## MEMORANDUM

**To:** City of Newton Planning & Development  
**From:** Peer Review Consultant Team  
(Form + Place, Horsley Witten Group, Inc., Utile)  
**Date:** January 23, 2020  
**Re:** Riverside Station, Newton, Massachusetts  
Site Design, Open Space, and Grove Street Review Summary

### SUMMARY

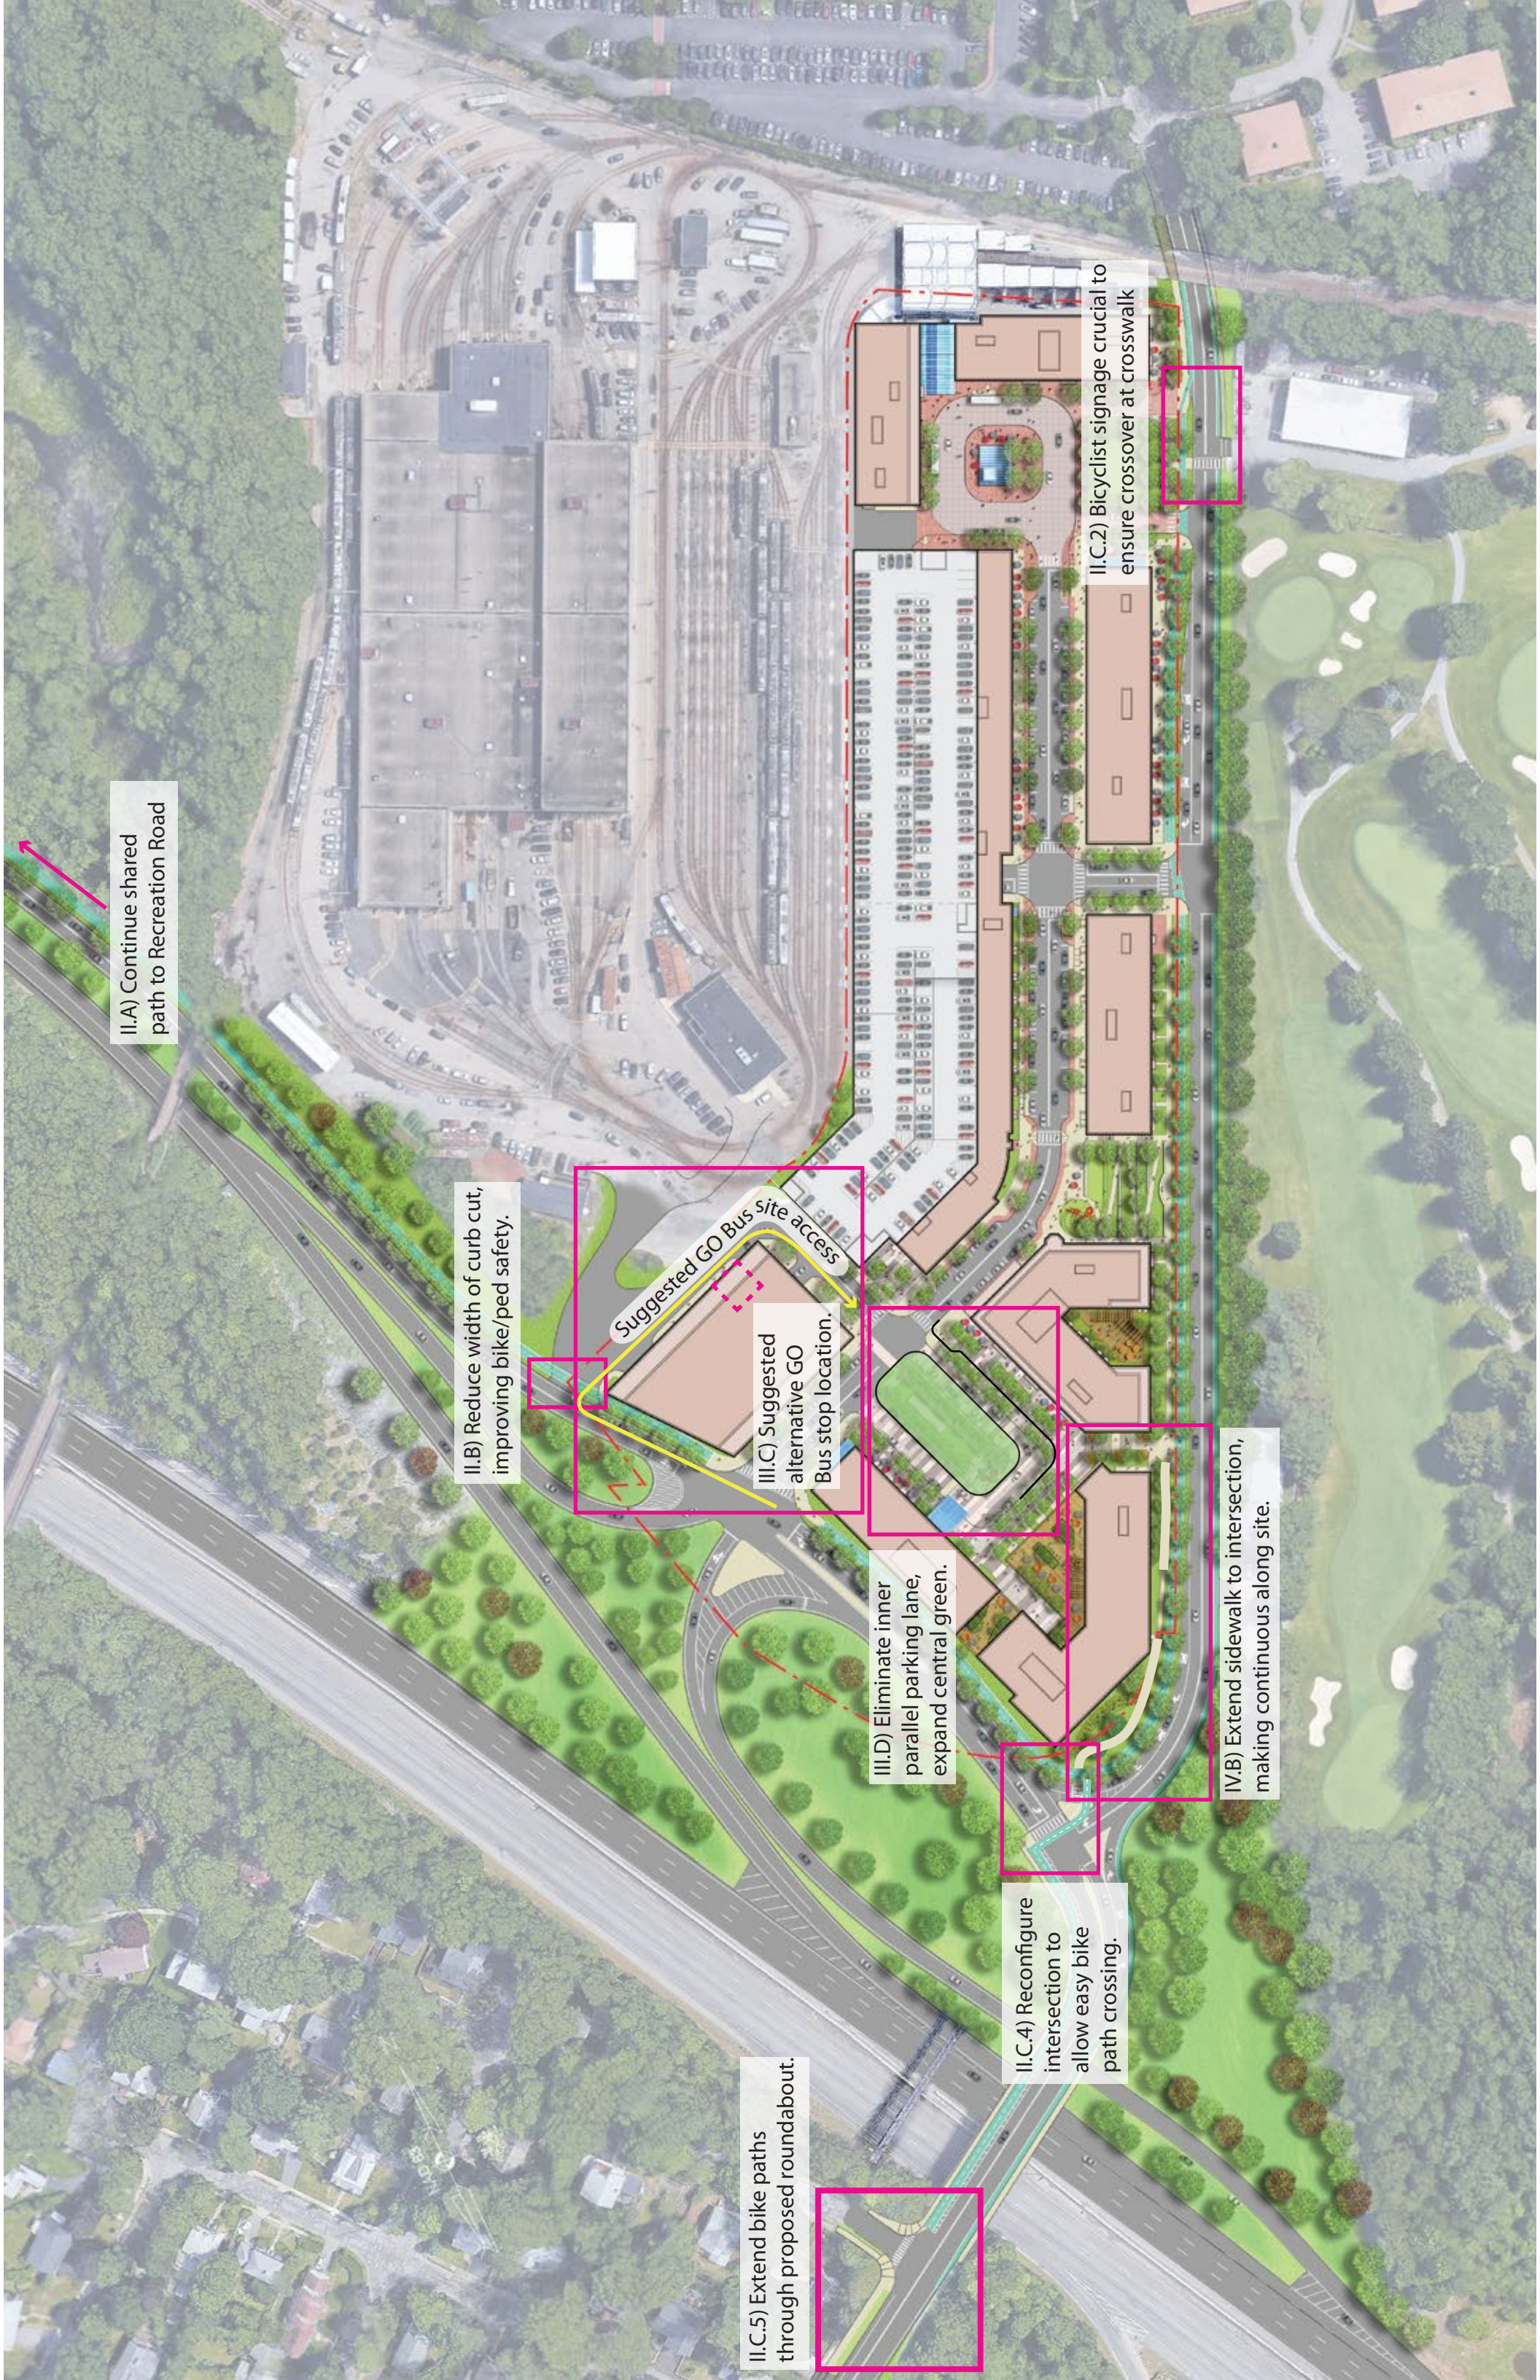
12. (U) The proposed shared-use path should be extended to Recreation Road, rather than ending at the bridge over the Charles River as currently proposed. We recommend a 14'-wide shared bicycle/pedestrian path on the northeast side of the road in order to provide two-way access for all users while ensuring separation from vehicular traffic entering and exiting the highway. This would still maintain sufficient right-of-way on the existing bridge structure for two 11' vehicular lanes. See attached diagram.

13. (U) The curb cut behind Building 1 that leads to the MBTA rail yard should be narrowed to improve safety for bicyclists and pedestrians using the shared-use path. See attached diagram.

- b. For northbound bicyclists using the two-way, off-street bicycle path on the west side of Grove Street, clear signage will be necessary at the curb cut between Building 6 and Building 7 to ensure that north-bound cyclists use the crosswalk to cross Grove St. and continue northbound in the on-street bicycle lane. See attached diagram.

- d. At the intersection of Grove St. and the I-95 exit ramp, a pedestrian crosswalk is proposed, but the two-way bicycle path does not have a dedicated space for crossing. In order to provide safe and adequate space for both bicyclists and pedestrians, the bike path should continue across both the exit ramp and the right turn lane from Grove Street parallel to the pedestrian crosswalk, with sufficient space in the refuge island for both bicyclists and pedestrians making the two-stage crossing. See attached diagram.

- e. The two-way bicycle path on the northwest side of Grove Street is shown as continuing south/southwest over the bridge over I-95, but it terminates just on the far side of the bridge. The two-way bike path on the northwest side of Grove St. should be extended through the proposed roundabout at the Grove St./Quinobequin Rd. intersection, creating a safer connection to and from Lower Falls. See attached diagram.

### Hotel Square

47. (U) The Transit Square is the most appropriate location for the GO Bus station. If this is impossible, consider placing the GO Bus station in Building 1. Buses could enter the site by traveling north on the on-ramp and using the curb cut for the MBTA railyard, thus avoiding the need to turn around within the site. There is a proposed amenity space on the ground floor of Building 1 adjacent to the proposed MBTA office space, this could be repurposed as the GO Bus stop. See attached diagram.

58. (U) The sidewalk along Grove St. should be made continuous along the site's frontage. The proposed small segment of sidewalk along Building 3 should be extended to connect with the rest of the sidewalk along this half of the site, and with the nearby reconfigured intersection. See attached diagram.

II.A) Continue shared path to Recreation Road

II.B) Reduce width of curb cut, improving bike/ped safety.

Suggested GO Bus site access

III.C) Suggested alternative GO Bus stop location.

III.D) Eliminate inner parallel parking lane, expand central green.

IV.B) Extend sidewalk to intersection, making continuous along site.

II.C.4) Reconfigure intersection to allow easy bike path crossing.

II.C.5) Extend bike paths through proposed roundabout.

II.C.2) Bicyclist signage crucial to ensure crossover at crosswalk

2.a) Suggested Recreation Road Access

**(HW) The Proponent indicated that these connections will be made, but have not yet been fully designed or added to the plan. Additional information should be provided for review as soon as it is available.**

**(HW) The Proponent indicated that the connections and details noted in comments a-e above will be addressed, but have not yet been fully designed or added to the plan. Additional information should be provided for review as soon as it is available.**

**(HW) The Proponent agreed to study removal of the parallel parking from the center of Hotel Square in order to widen the usable public space.**
